DESIGN ADVISORY BOARD Tuesday December 8, 2015 at 3:00 PM Conference Room 12, City Hall, Burlington, VT Agenda

MEMORANDUM

To: The Design Advisory Board
From: Mary O'Neil, AICP, Principal Planner
RE: ZP16-0622CA; 351 North Avenue
Date: December 8, 2015

File: ZP16-0622CA
Location: 351 North Avenue
Zone: WRM **Ward:** 4N
Date application accepted: November 17, 2015
Applicant/ Owner: Eric Farrell / E.F. Farrell, LLC
Request: Change roof material from slate to standing seam copper on former orphanage building.

CONCEPTUAL STORM DESIGN

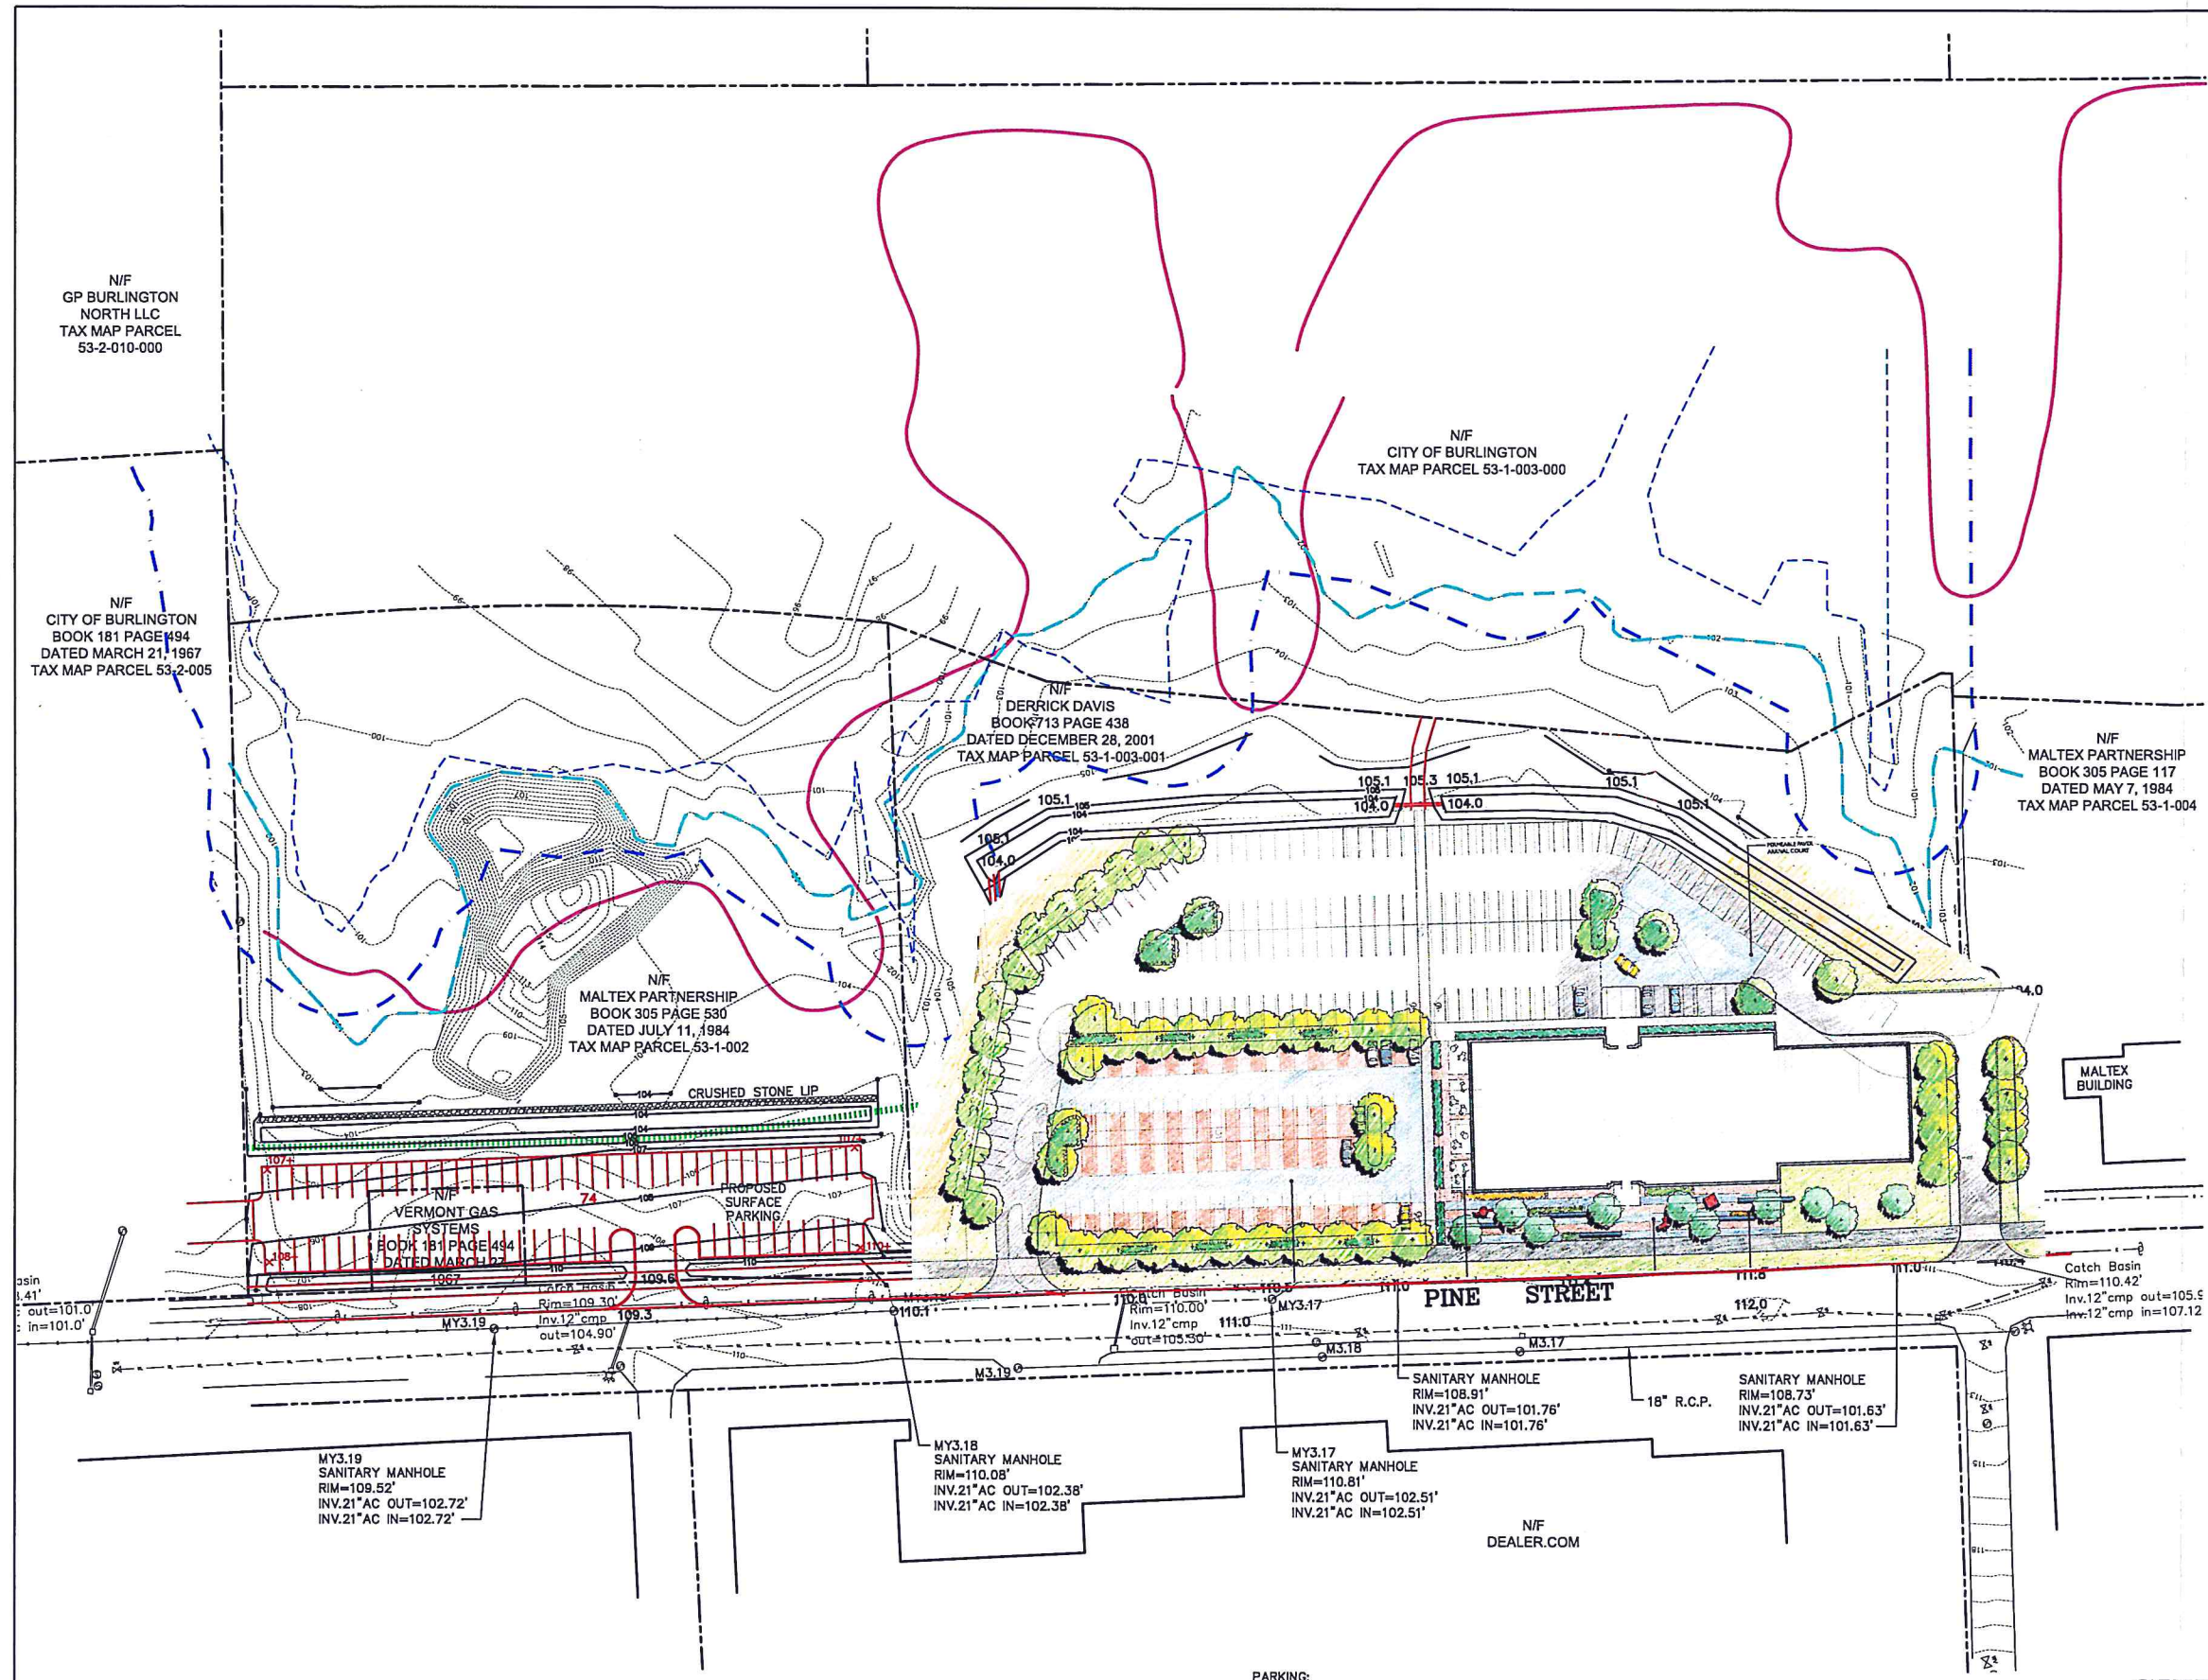
Some basic stormwater information has been provided in the sketch plans. Areas of permeable pavers are proposed along with linear stormwater attenuation structures alongside the surface parking areas. Performance details must be included in the permit application. The applicants are advised to work with the Burlington Stormwater Program to work out proposed stormwater improvements prior to permit application.

SITE PLAN

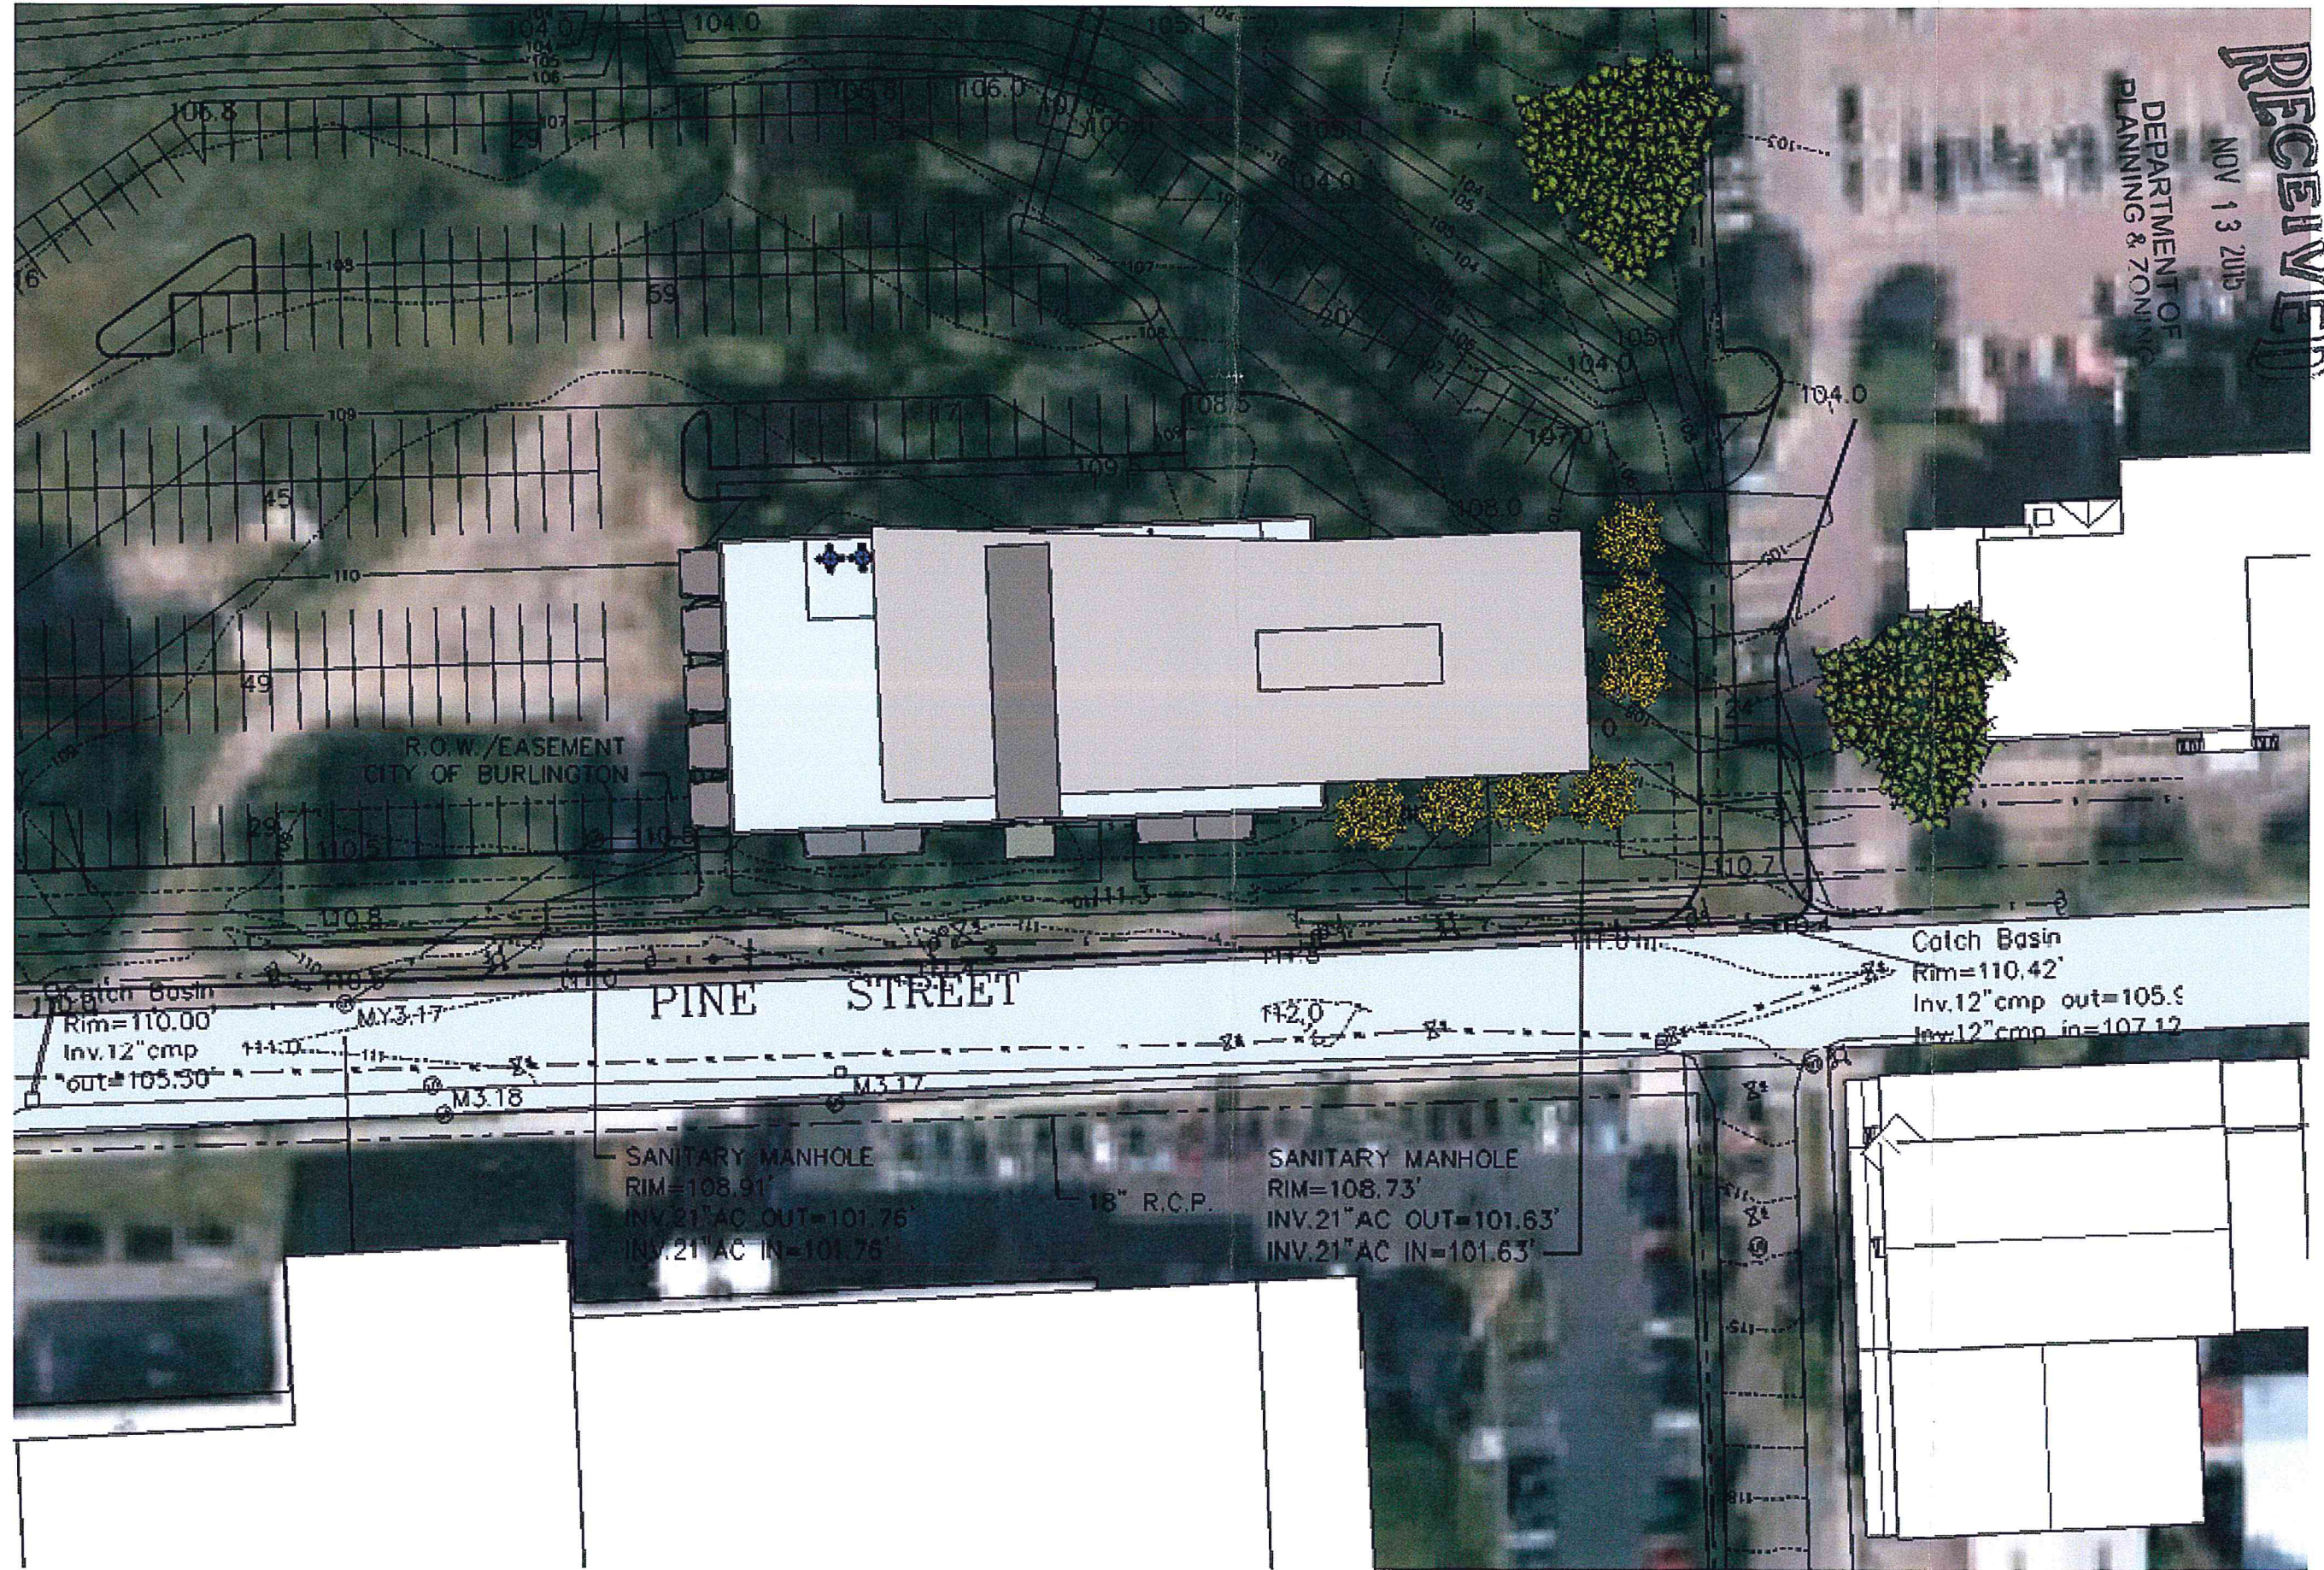
The two properties do not contain any important natural features as identified in the Open Space Protection Plan or as outlined in Sec. 4.5.4, *Natural Resource Protection Overlay Districts*. The properties are, however, affected by the buffer zones for several such natural resource overlays. Specifically, wetland and natural area buffer zones originating on properties further west extend onto the subject properties. The site plan depicts a 50' wetland buffer (i.e. the state buffer width); however, the city's wetland buffer is 100' wide and must be depicted for an accurate evaluation of buffer impacts. The site plan does not depict the 100' natural area buffer zone at all and must.

The existing properties are fairly flat and will essentially remain so. Fill and grading work will be required for construction, and the sketch plans depict some topographic information. The permit application must include a detailed topographic plan.

A new or reconstructed sidewalk appears to run across the length of 453 Pine Street. The sketch plans are unclear as to whether it would extend across 501 Pine Street as well. Such continuation is recommended for ease of pedestrian access. In any event, work within the Pine Street right-of-way will require the approval of the City Council in consultation with the Department of Public Works.

The space between the building and the sidewalk will be hardscaped with pavers to form an entry courtyard with sitting benches and artwork. This hardscaping will provide a strong connection between the building's front entry and the public sidewalk. Sidewalks must continue across the driveways. The sketch plans appear to depict as much, but details are lacking. Perimeter walkways hug most of the building foundation, and a new central walkway is proposed through the center of the surface parking area on 453 Pine Street. Additional walkways interior to the surface parking areas are recommended for improved pedestrian circulation and safety.

The proposed building is set close to Pine Street with parking placed to the side and rear of it. Site conditions related to peat soils and coal tar contamination effectively prevent placing all of the parking behind the building. Surface parking areas are broken into several sections, and the parking next to the proposed building will receive a surface paver treatment aimed at enabling alternative uses during weekends. The sketch plans depict landscaping between the parking and the sidewalk. Details as to the proposed landscaping and its effectiveness for screening will be required with the permit application. Little detail is provided for the surface parking at 501 Pine Street. It is placed up close to the street with no screening depicted in the sketch plans. If this parking area is to be constructed, it should be heavily screened.

In light of the reduced-size sketch plans, the dimensional adequacy of the proposed parking spaces and associated circulation cannot be assessed. The permit application will require full size true-to-scale drawings to enable such assessment. While not within the purview of the Design Advisory Board, it bears noting that the number of parking spaces proposed, 332 (258 at 453 Pine St + 74 at 501 Pine St), is far above the minimum parking requirement of 200 spaces (2 spaces per 1,000 sf for 100,000 sf office building). This many parking spaces may exceed the maximum parking limitation of 8.1.9, *Maximum Parking Spaces* and may, therefore, require a waiver under criterion 5 of that section. Reduction in the number of parking spaces is strongly encouraged and may be required depending on the maximum parking waiver provisions.

All of the proposed surface parking will require the installation of new shade trees. No parking lot shading analysis is included in the sketch plans. This criterion establishes a target of 30% shading of the parking areas with new shade trees. At least 1 shade tree for every 5 parking spaces is required. Minimum caliper size at the time of planting is 2.5" – 3.5" and a mature canopy diameter of 35' is expected. Such details will be required with the permit application.
